BENDIX STREET, MANCHESTER

**REPORT TO DISCHARGE DRAINAGE
RELATED PLANNING CONDITION**

Report Title: Report to Discharge Proposed Drainage Related Planning Condition

Report Reference: BST-RDG-00-ZZ-RP-C-0002

SECTION THROUGH MH S05A TO MH C1

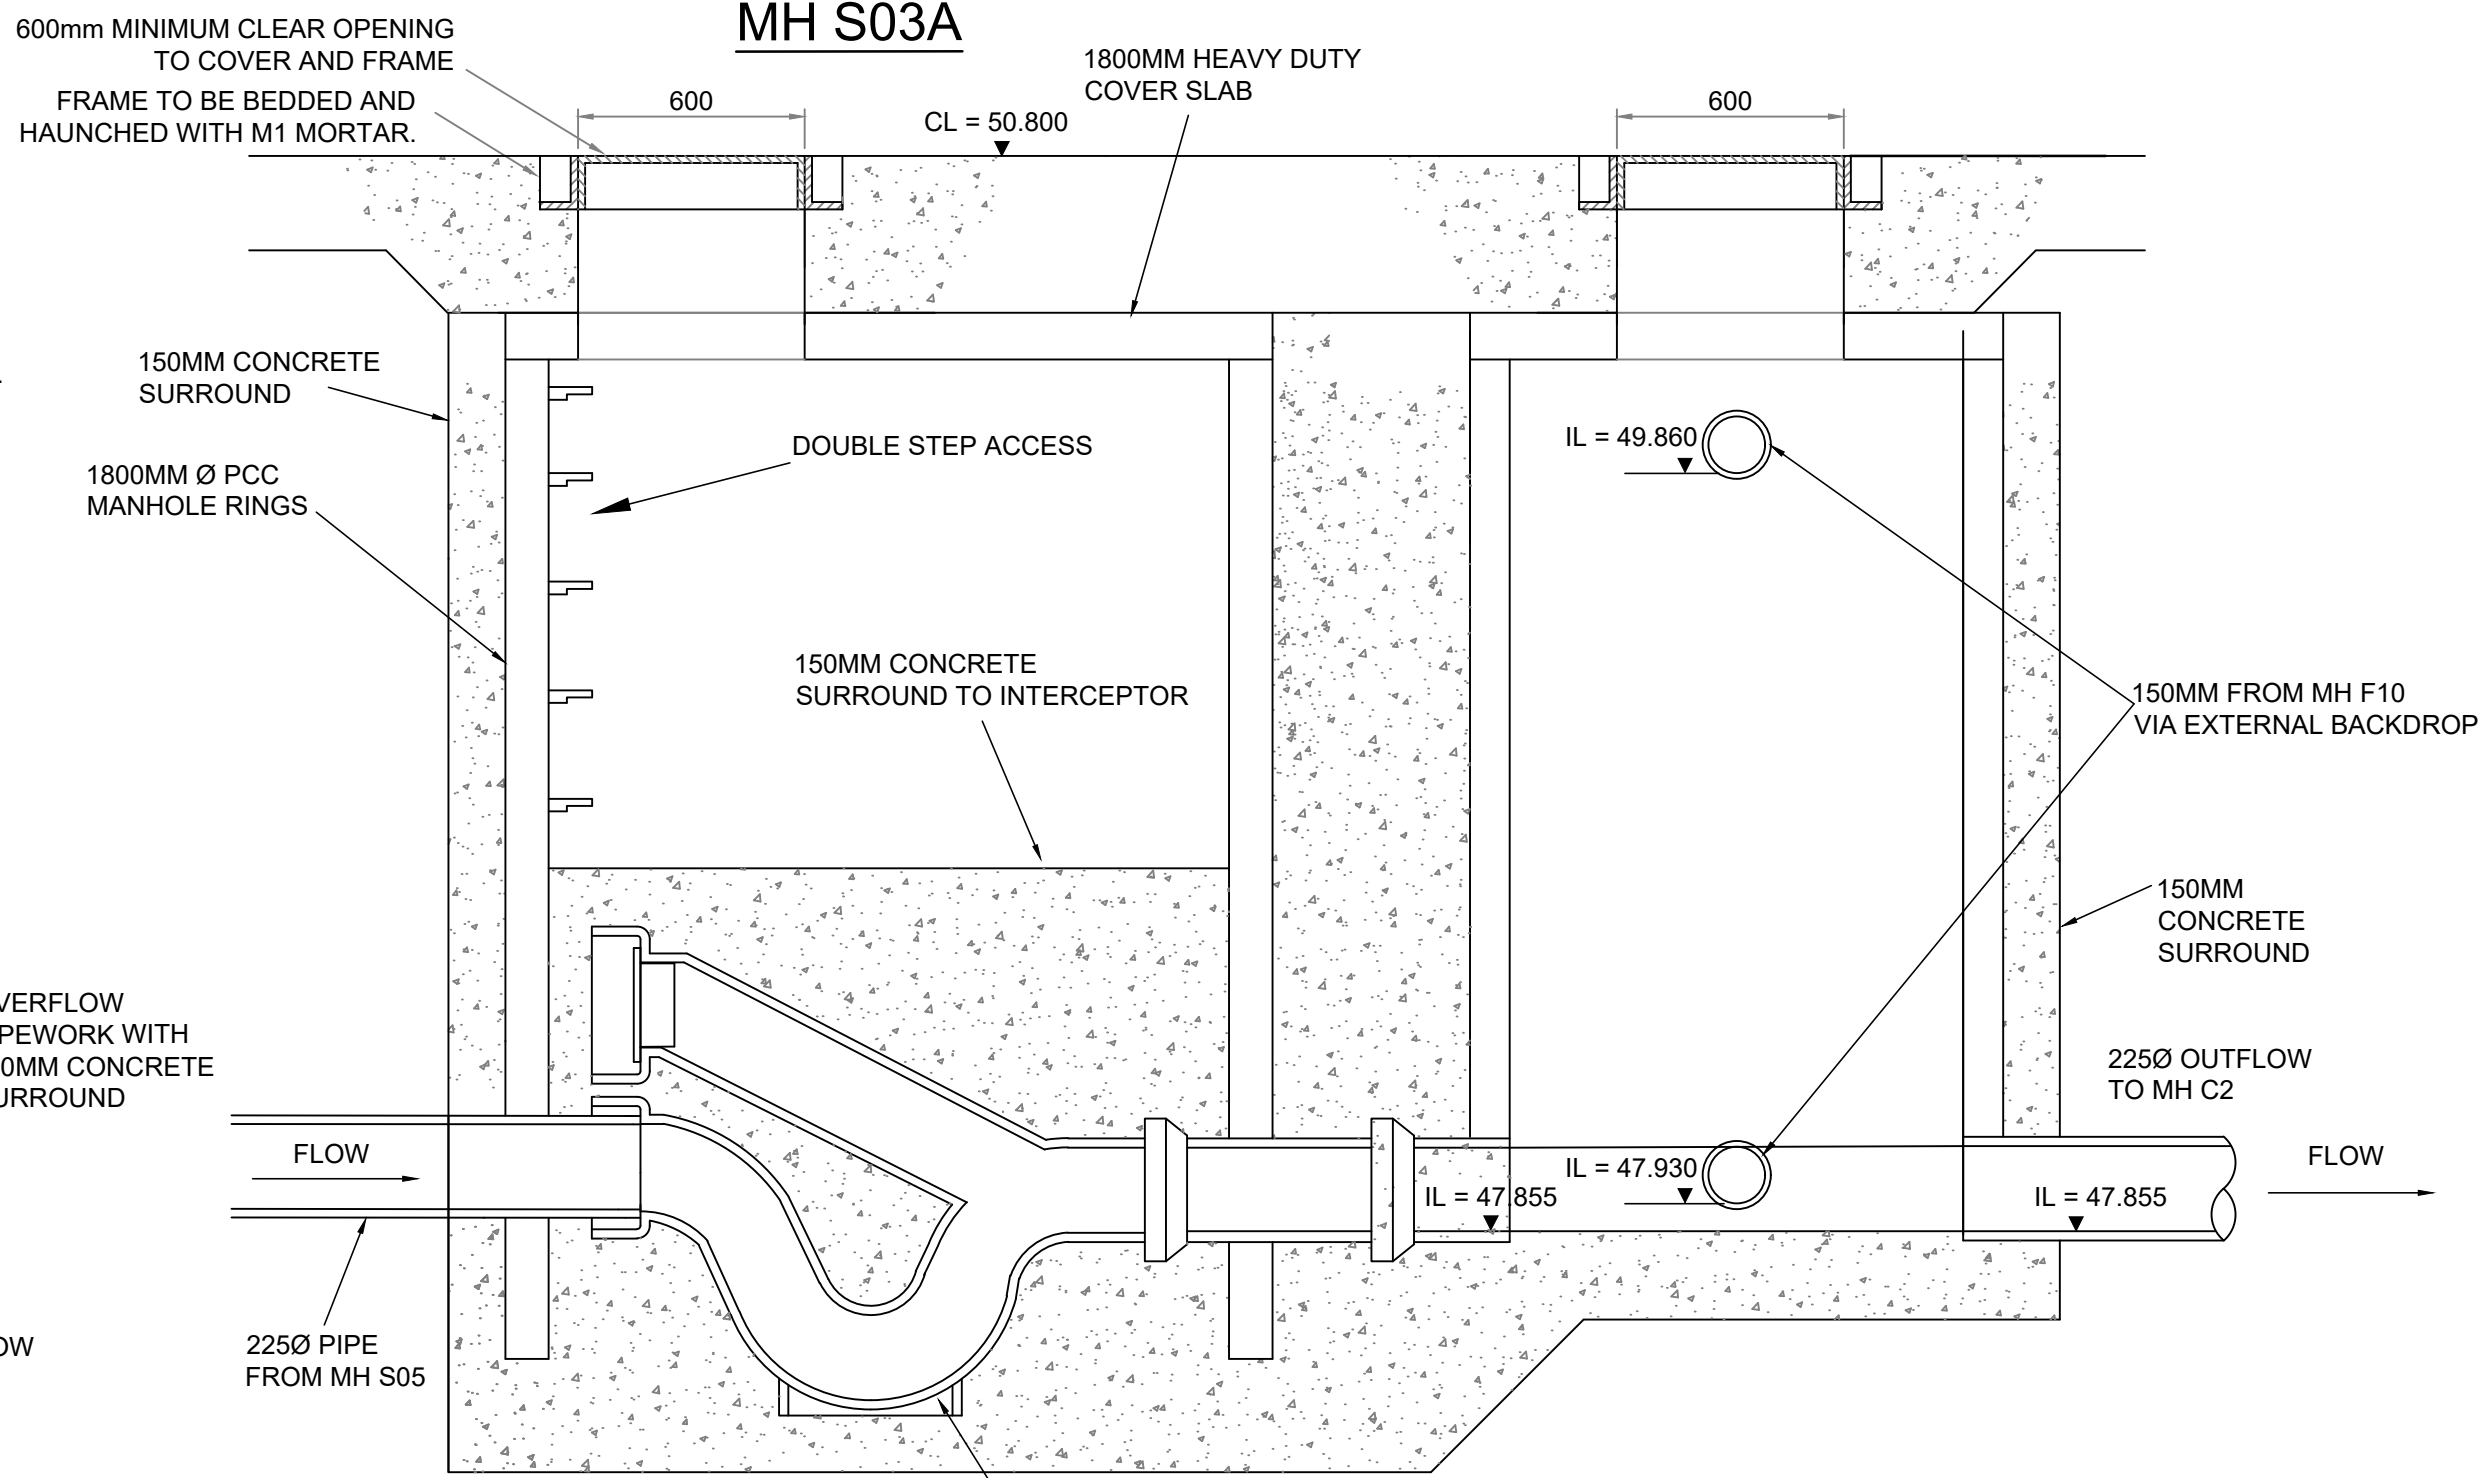
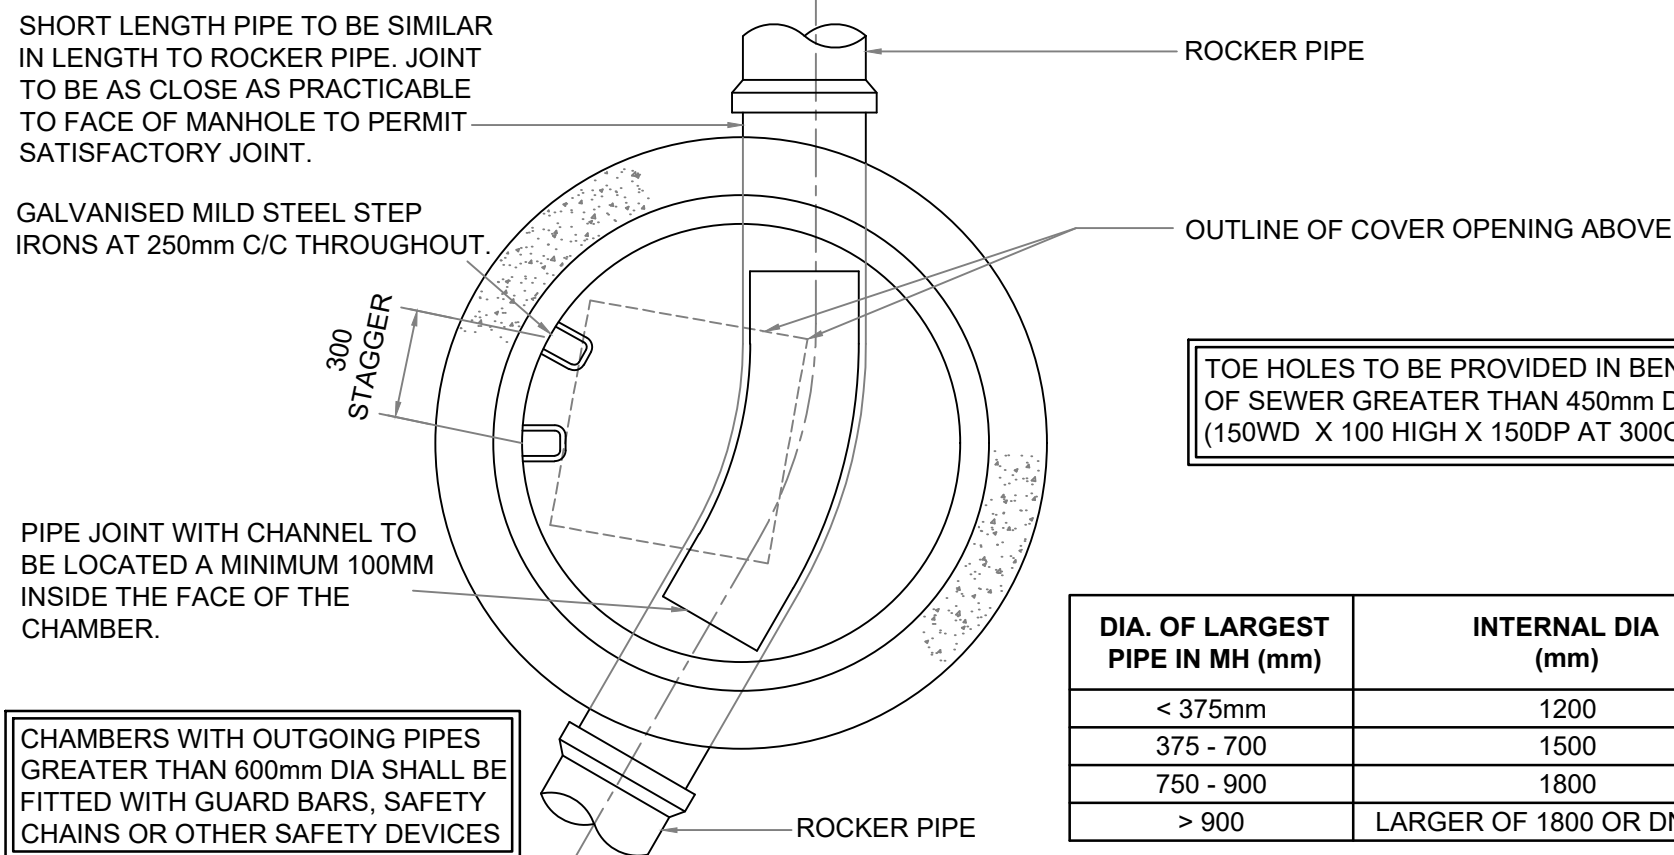
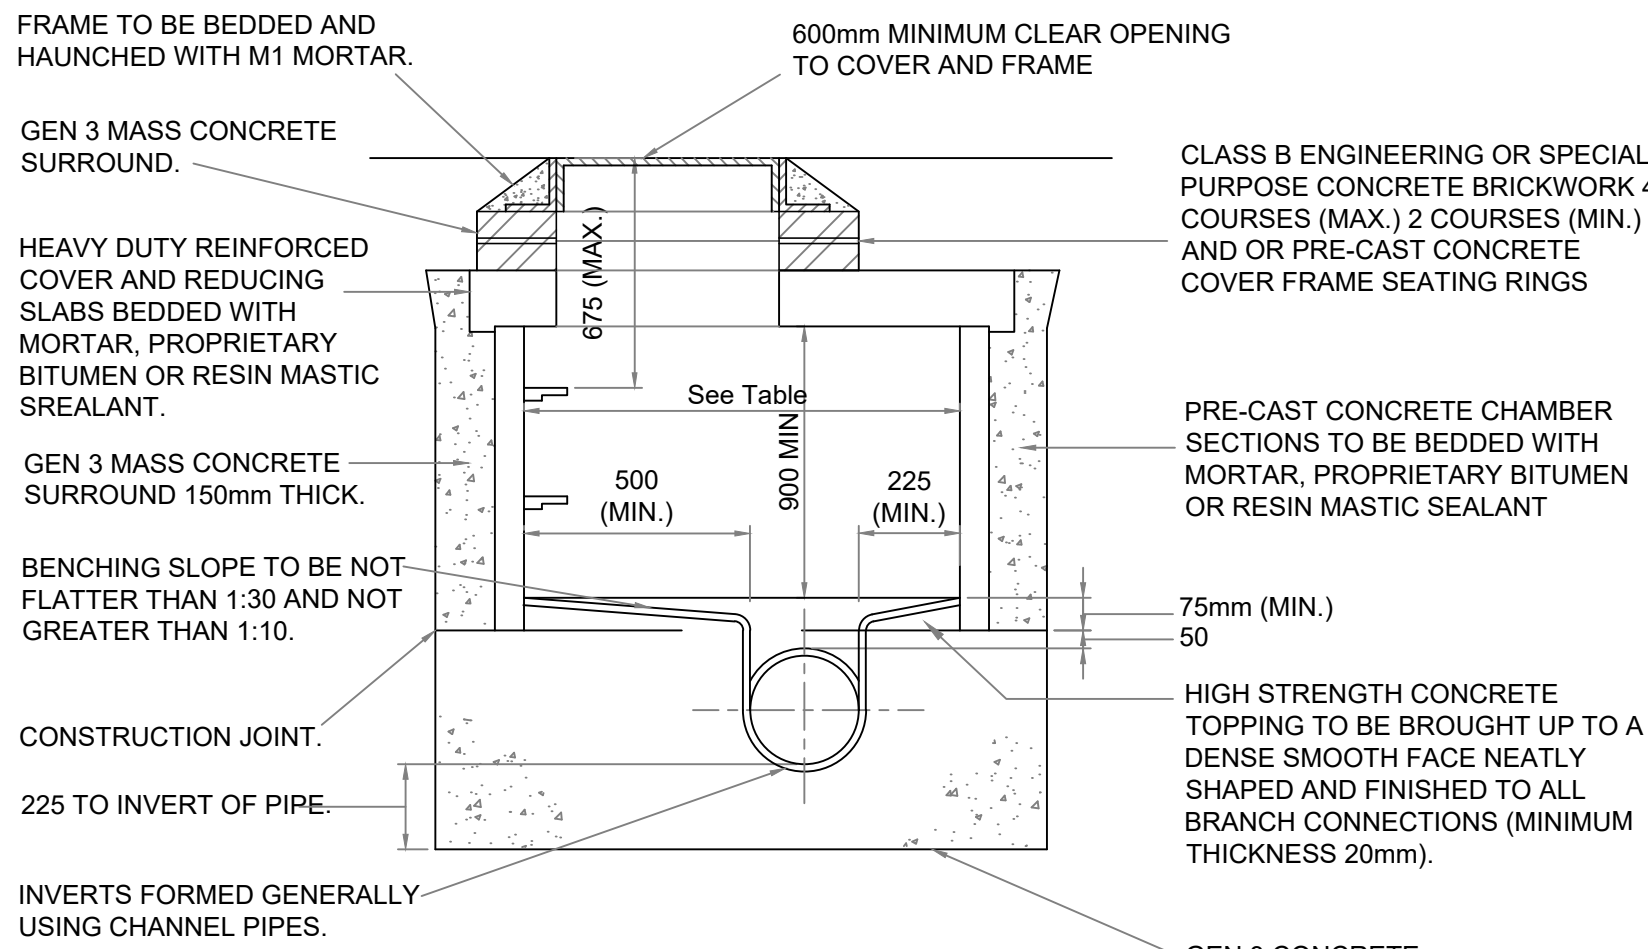
- *Construction details of flow control and SuDS elements*

For construction details refer to drawings BST-RDG-00-ZZ-DR-C-0102 & 0103 in Appendix A.
